GOVERNMENT OF INDIA
MINISTRY OF ENVIRONMENT, FOREST & CLIMATE CHANGE
Central Zoo Authority

F. No. 19-157/93-CZA(17)(Vol. IV)(NS)

Sub:- Revised Master (layout) Plan and revised design of enclosure for Peafowl at Deer Park, NFCL Green Belt, Kakinada, Andhra Pradesh-Reg.

DESIGN OF EXISTING ENCLOSURE OF PEA FOWLS.

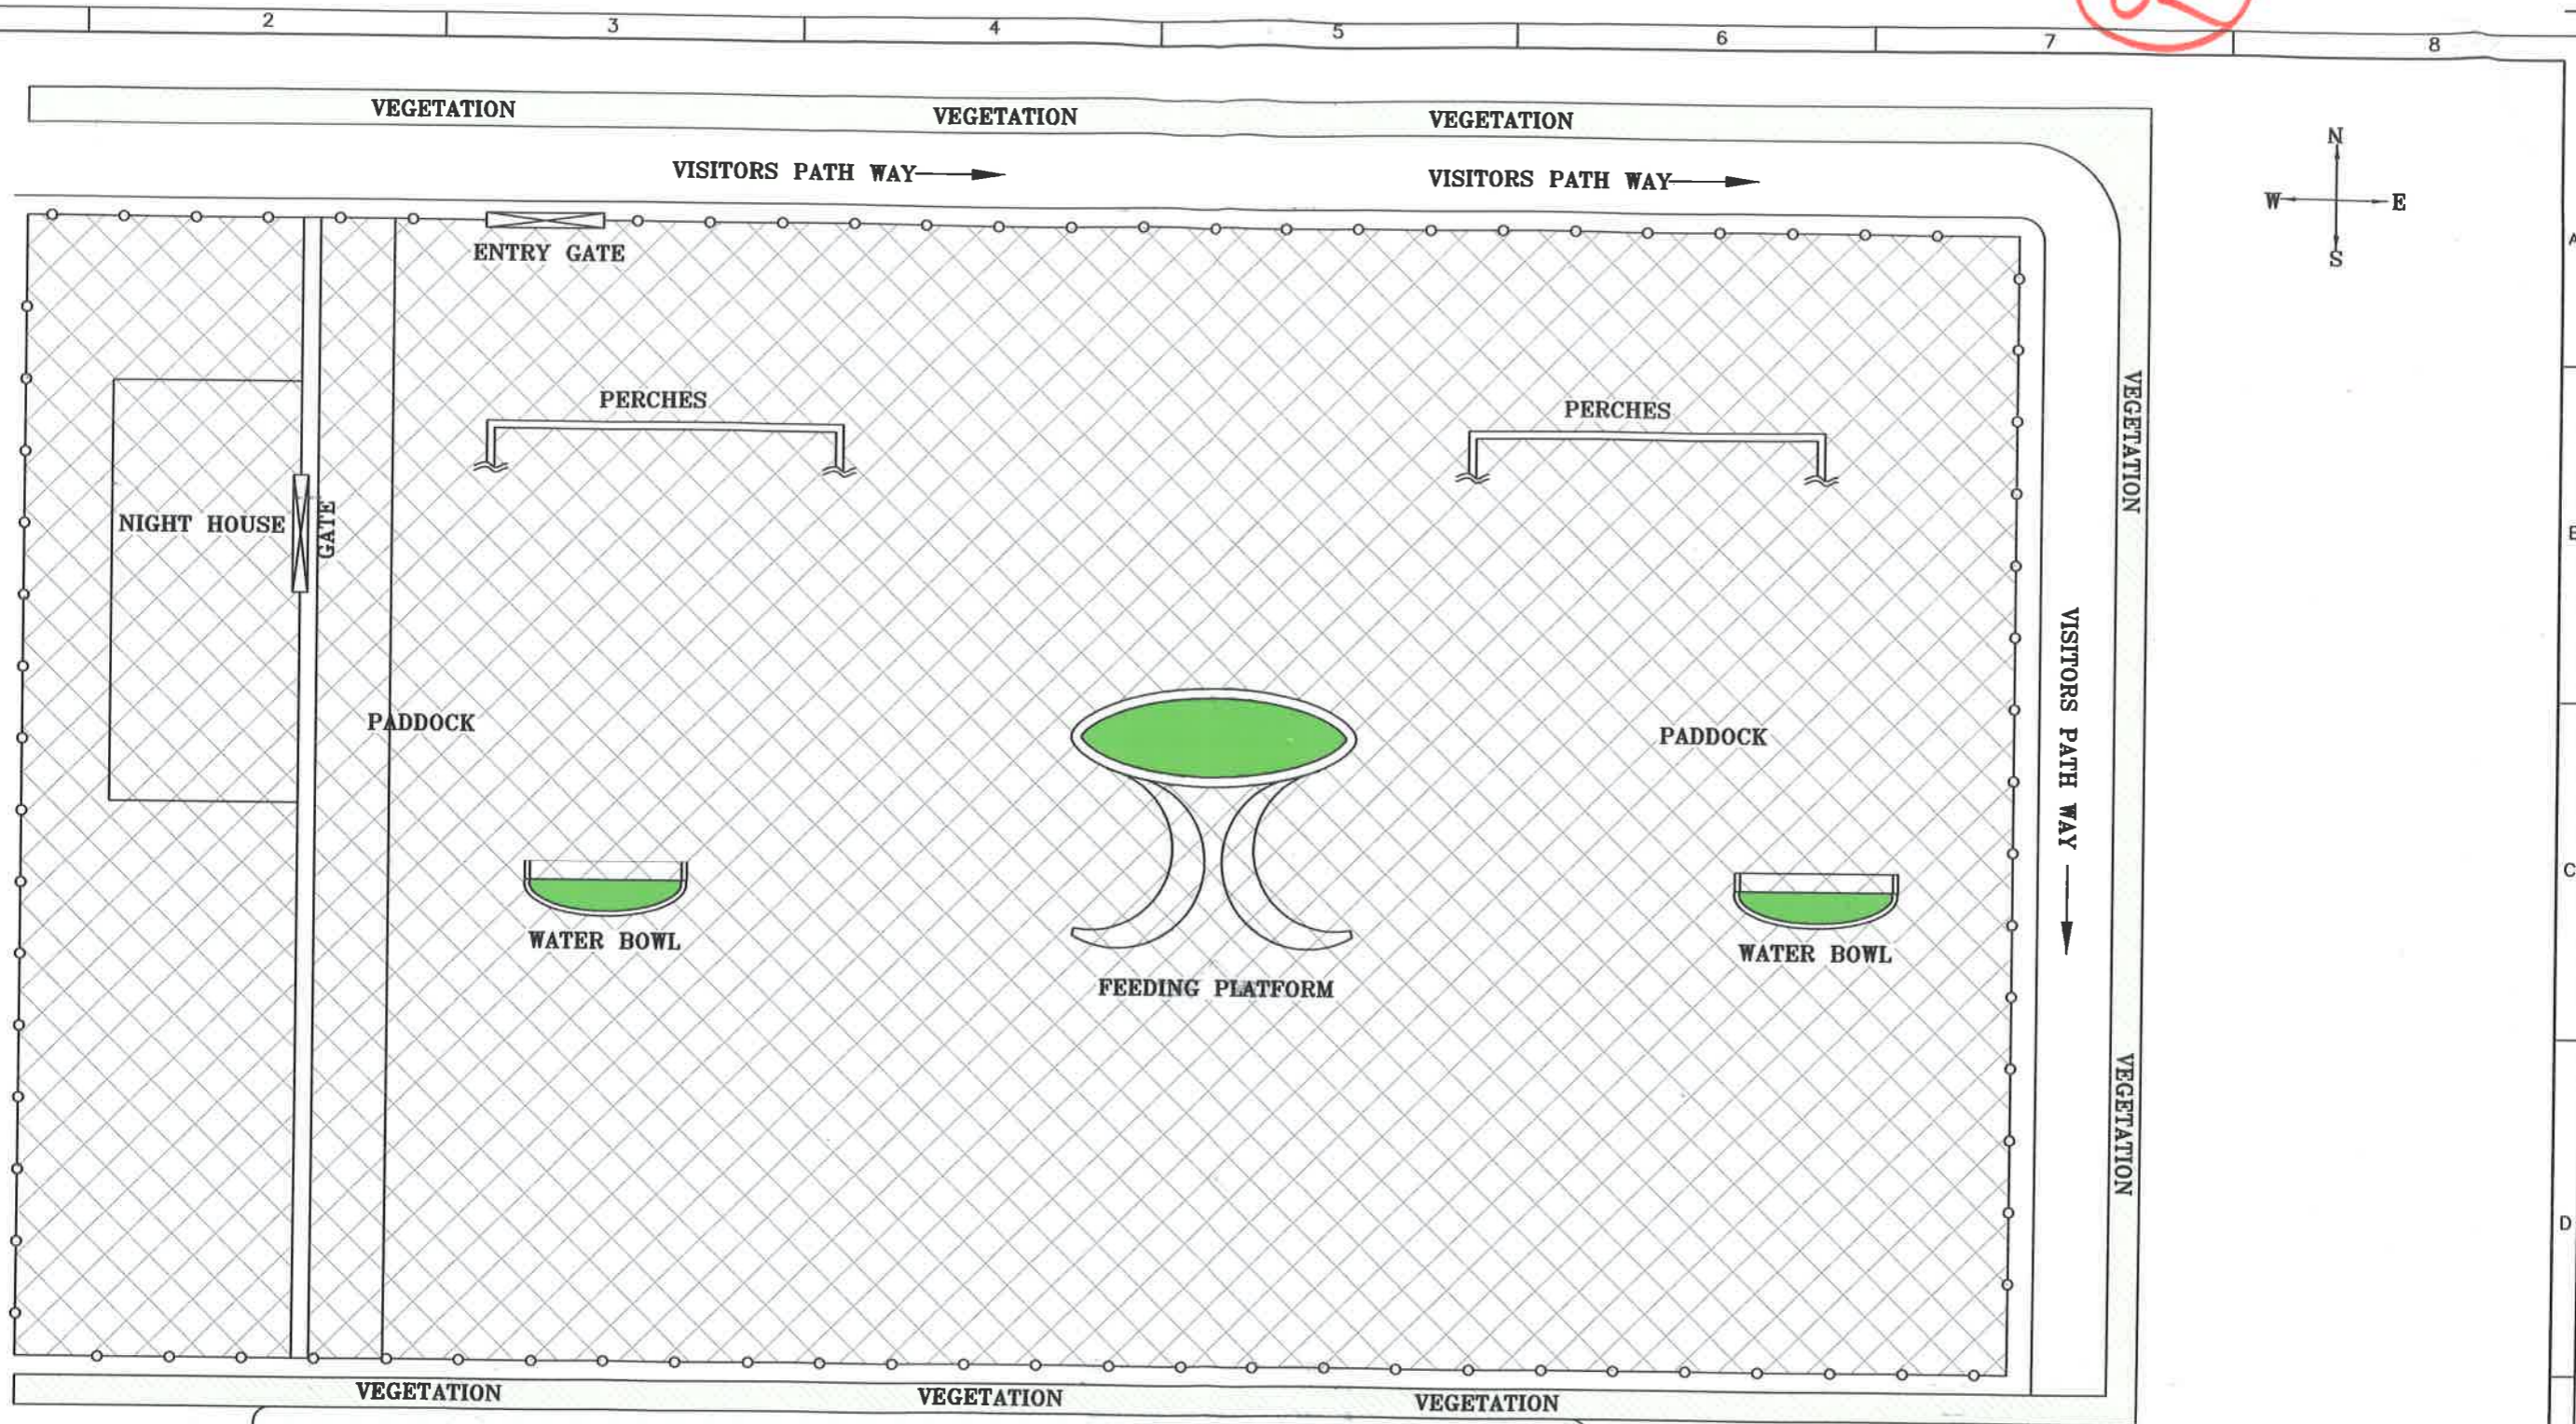
Further, the revised design of enclosure for Peafowl at Deer Park, NFCL Green Belt, Kakinada, Andhra Pradesh was also placed in the 65th meeting of the Expert Group wherein it was found in compliance with the earlier observation and approved.

height of enclosure should be increased to 4mt. minimum.
 Night house should have an independent access from outside (from outside other than visitors path side)
 The corners should be rounded off.
